Case #: PB 2014-03
Date: March 6, 2014
Recommendation: Conditional Approval

Updated* PLANNING STAFF REPORT

Site: 337-341 Broadway

Legal Notice: Applicant, Winter Hill Bank, FSB, and Owner, KLT Corp., seek a Special Permit under SZO §6.1.22, for new signage. CCD 45 zone. Ward 4.

337-341 Broadway – previous signs for Citibank – (top left) along Broadway, (top right) facing parking lot, (bottom left) pylon sign, (bottom right) elevation show for original special permit approval

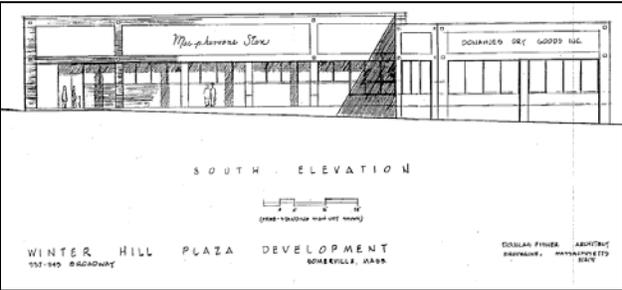
The third sign on the building is a new sign that does ~~not comply~~ as redesigned complies with the design guideline for signage in the CCD (§6.1.22.H). ~~Large interior lit box signs are discouraged and Planning Staff do not recommend approval of this sign with its proposed design. These signs are discouraged because they overwhelm the façade of the building. They are also oriented towards fast moving vehicles and in this district signs should be oriented towards pedestrians creating a positive experience along the street. Existing or future businesses moving into the shopping center or neighboring properties will likely want to install larger signs with the same level of or brighter lighting to compete with the signage that is proposed for this tenant. The sign has been redesigned with individual letters that are halo lit. This type of lighting is softer and provides more visual interest. The letters will sit on a painted cabinet that will not glow.~~

~~Planning Staff find that if the third sign is made of a material that is not discouraged (vinyl or plastic) and is either not lit or externally lit, it will not be as dominant and would be acceptable. Ideally the other two signs on the building would also comply with this standard.~~
